TECHNICAL
POLICY AND PROCEDURE NOTICE #3/92

TO: Distribution
FROM: Richard C. Visconti, A.I.A. *rw*
Assistant Commissioner
DATE: May 11, 1992
SUBJECT: Local Law 58/87 - Acceptable Prototypical Kitchen

KITCHEN (GALLEY TYPE) 'K3c'

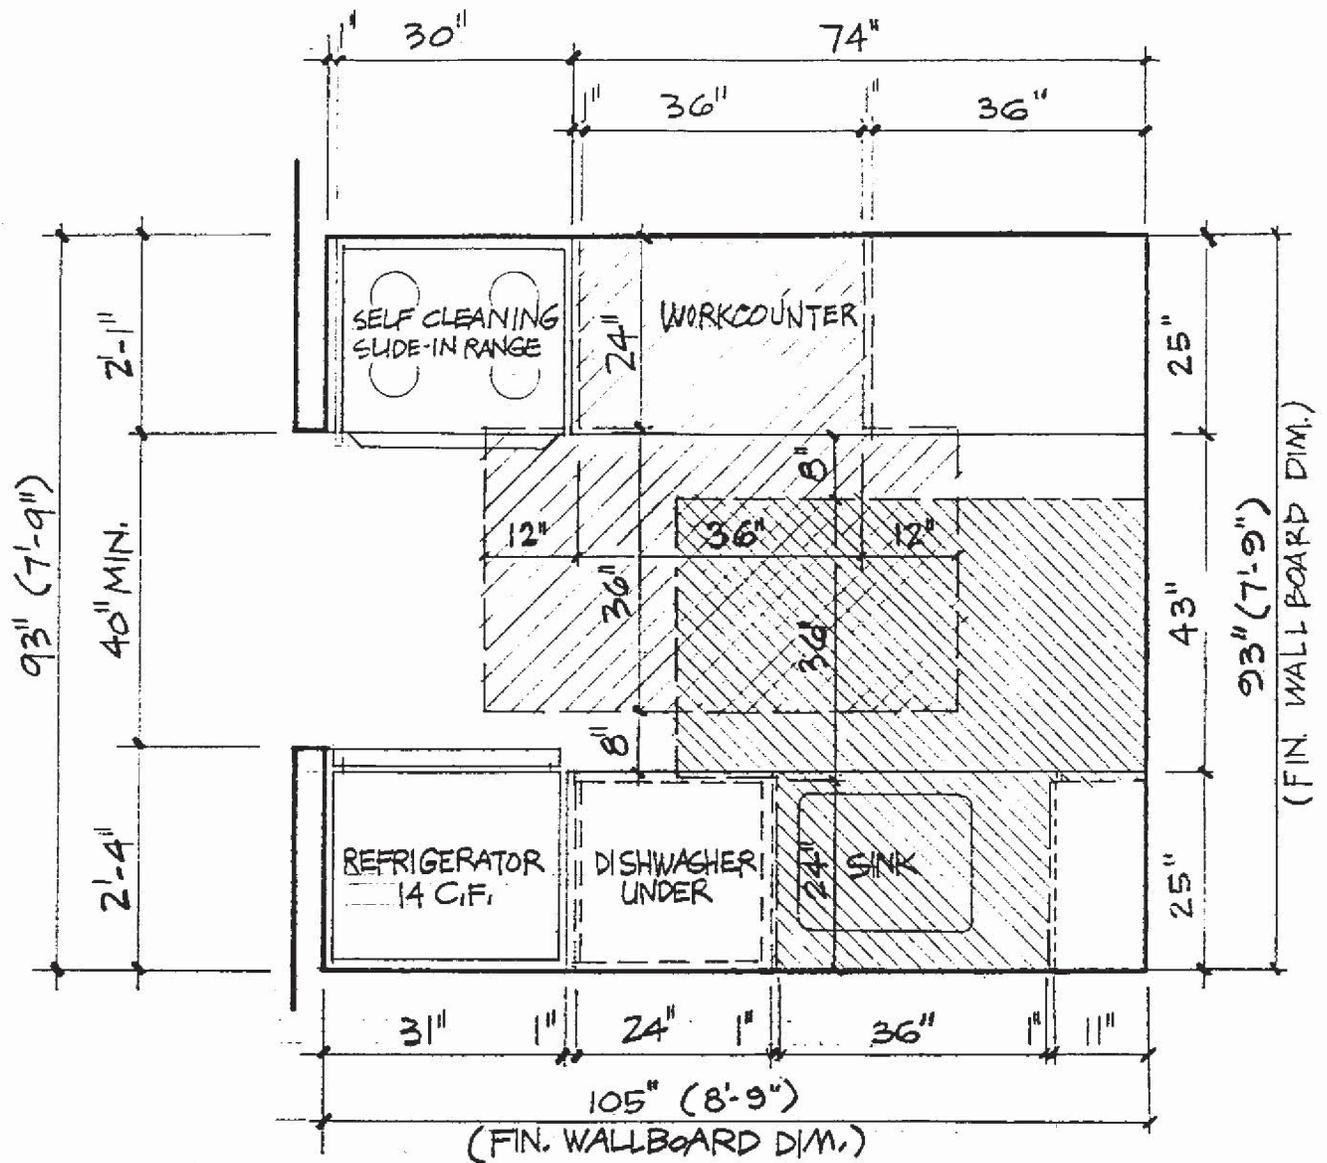
The annexed galley type kitchen with T-shaped turn space, "K3C", has been determined to be an acceptable prototype, in compliance with Local Law 58/87.

Alternative placements of the kitchen appliances may be permitted provided that all minimum dimensions are maintained and the t-turn space is not encroached upon.

SHOWING COMPLIANCE TO T-SHAPED TURN SPACE
(AT WORKCOUNTER AND AT SINK CABINET)
